# SERVICE BULLETIN

No. D-170

FLUID COUPLING

SQUEAL

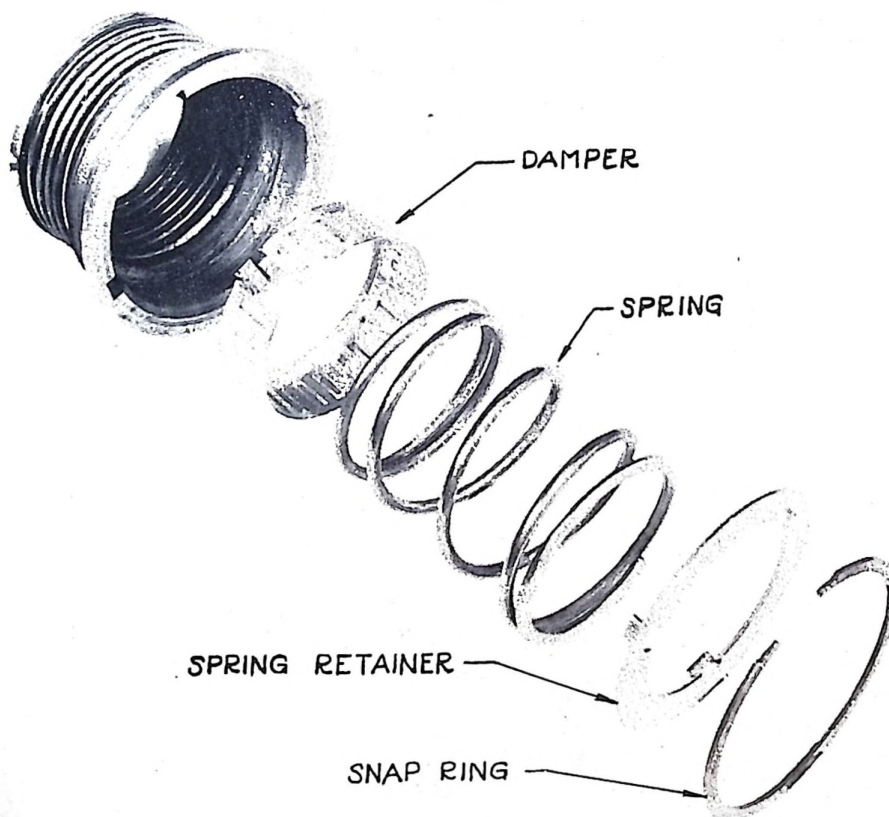
Effective Car Serial #30727536 a damper was added to the fluid coupling seal assembly to prevent fluid coupling seal squeals. An exploded view of the damper and its adjoining parts is shown below.

This damper (Part #1112754) is available for service and should be installed in case of persistent squeal in cars built before the effective serial number. The procedure outlined in Bulletin #D-159 of replacing the seal ring should no longer be followed. It is now only necessary to replace the ring when signs of leakage are evident.

7. Install damper (Part #1112754) over front end of spring, replacing spring with a counter clockwise twist to insure proper seating of spring and damper in bellows. Reinstall spring retainer and snap ring again using Miller Tool #C-613 to compress the spring.
